1997 Chrysler 3.5L Water Pump — 3 or 6 Mounting Holes?

1997 Chrysler Concorde, Chrysler Intrepid (Canada), Chrysler LHS, Dodge Intrepid and Eagle Vision with 3.5L engine.

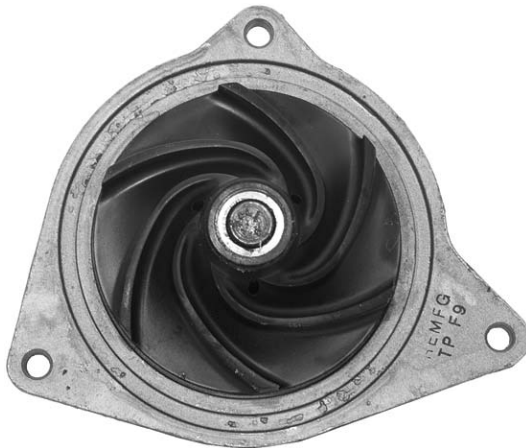
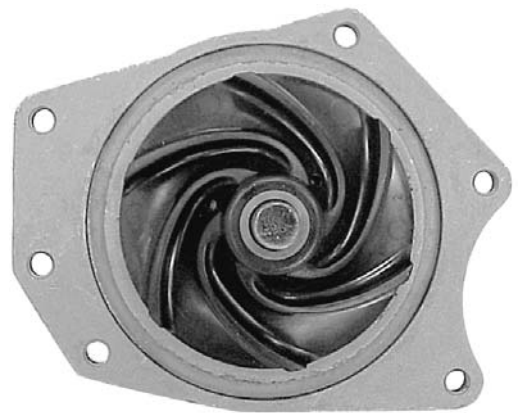
Original water pump does not match replacement unit – the number of mounting holes is different.

Mid-year design change by the OEM.

CARDONE is now supplying two different housings. The part numbers are 58-541 and 58-564.

58-541 with 3 mounting holes

58-564 with 6 mounting holes
